UNITED STATES PATENT AND TRADEMARK OFFICE

| APPLICATION NO. | FILING DATE | FIRST NAMED INVENTOR | ATTORNEY DOCKET NO. | CONFIRMATION NO. |
|---|-------------|----------------------|-----------------------|------------------|
| 10/824,915 | 04/15/2004 | Stephen Selle | 8206 | 7341 |

DETAILED ACTION

(PRIOR ART)

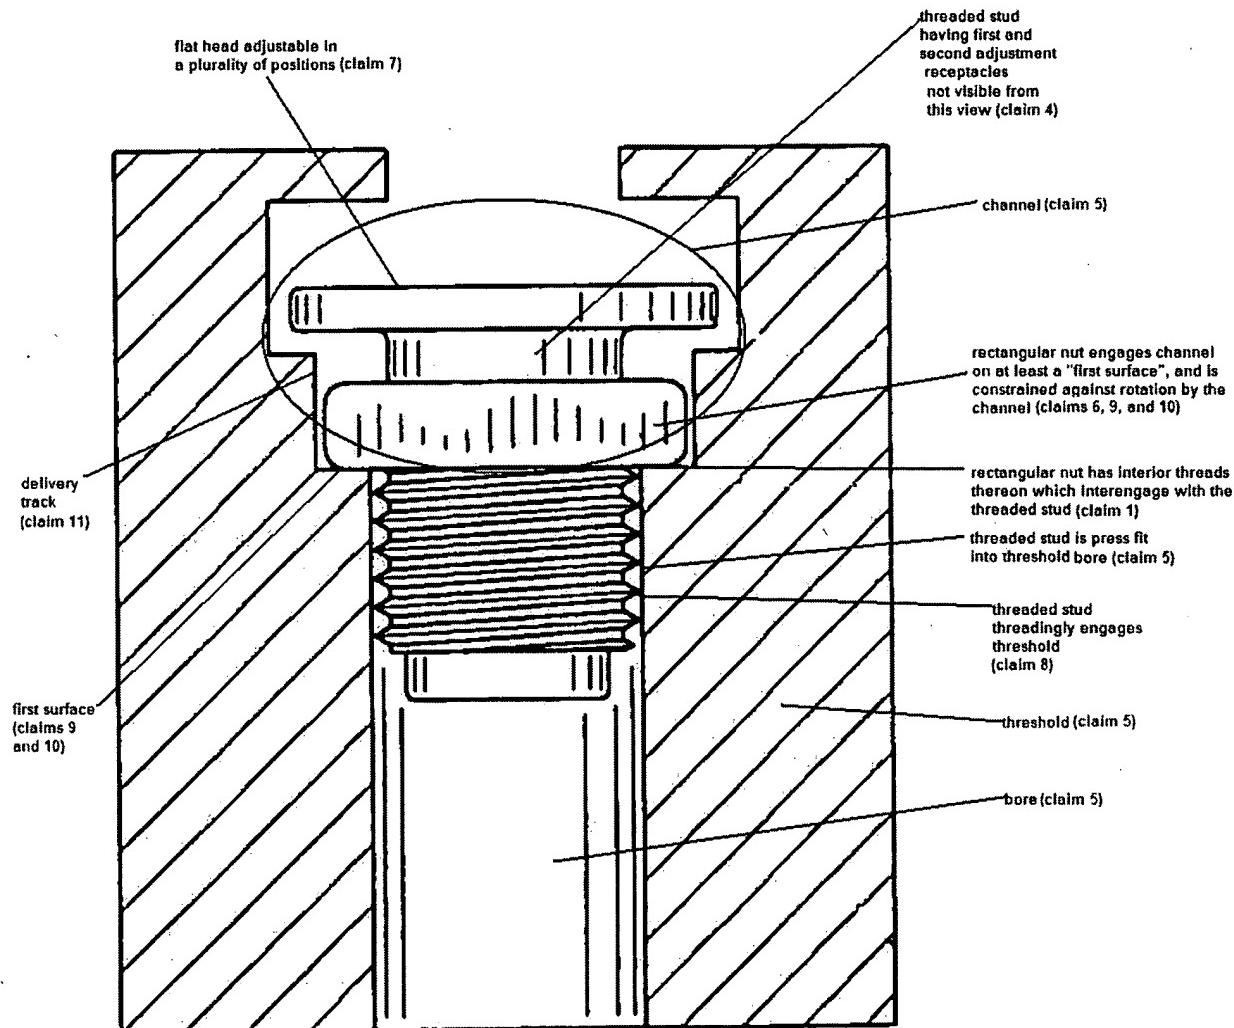
The delivery track shown in the drawings could be broadly construed as a "threshold" having a "channel" with a "bore therein". The examiner takes the position that all elements except for a raised crown and flanges are expressly disclosed in the prior art figures of the instant application.

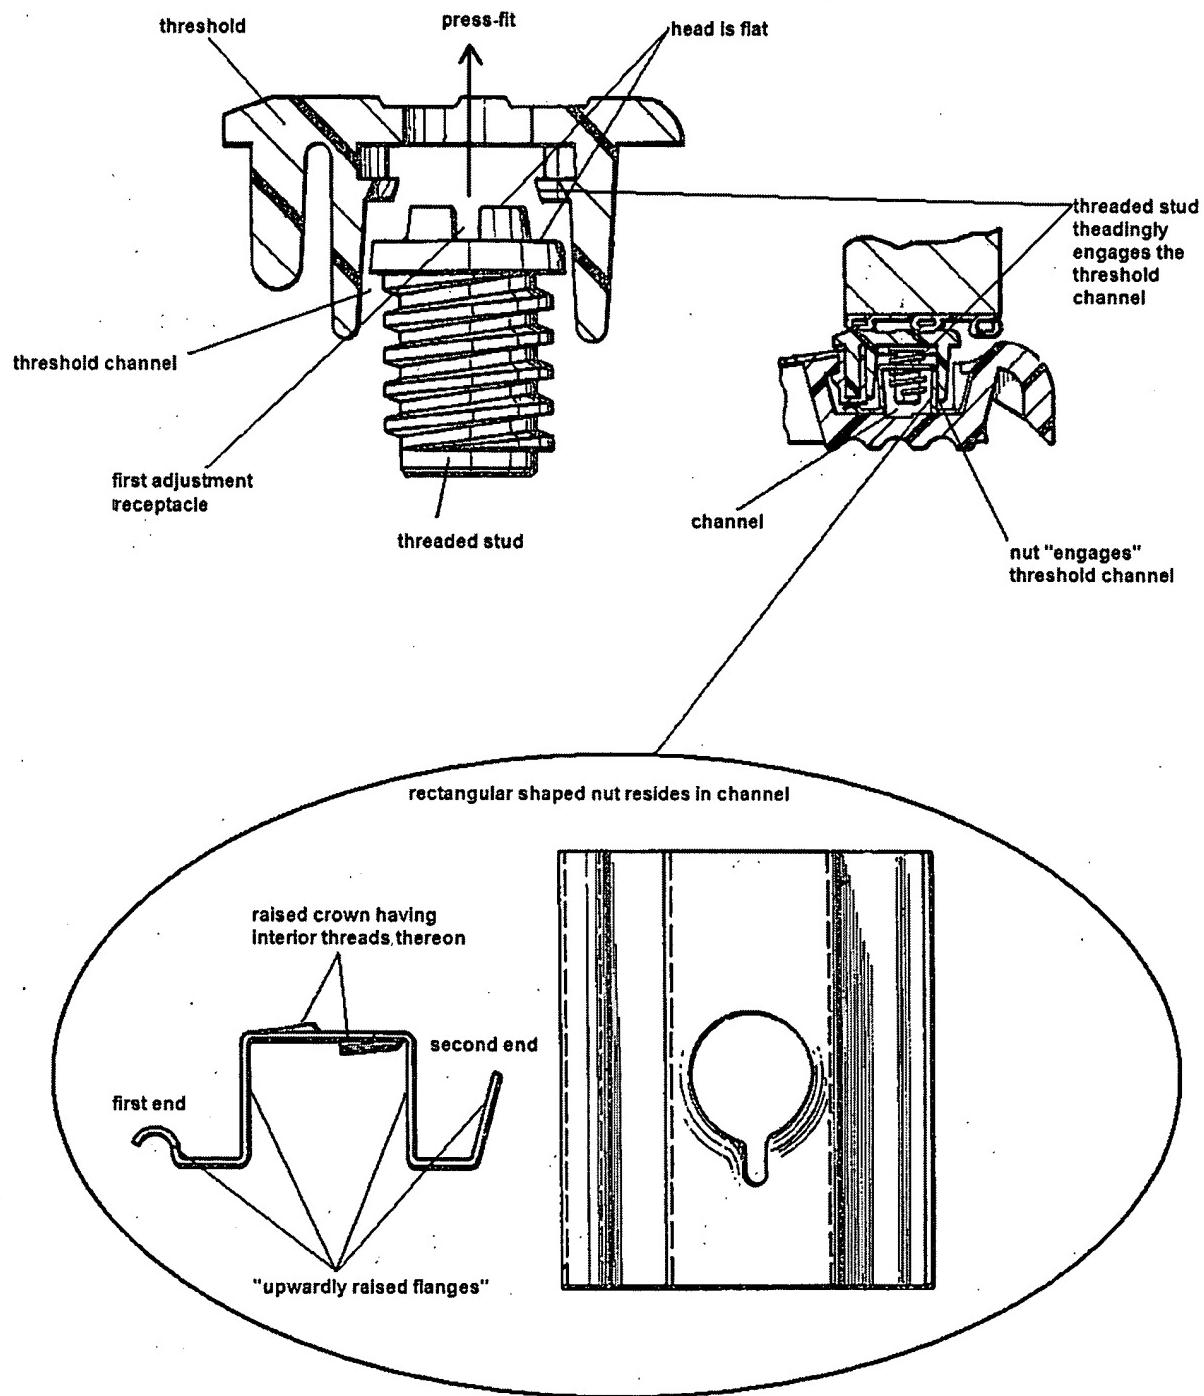
- [8] Claims 1-3, and 5-10 are rejected under 35 U.S.C. 102(b) as being anticipated by Bursk et al. US-4,352,258.

In short, Bursk substantially teaches each and every limitation found in claims 1-3, and 5-11 as clearly shown in the annotated drawing below.
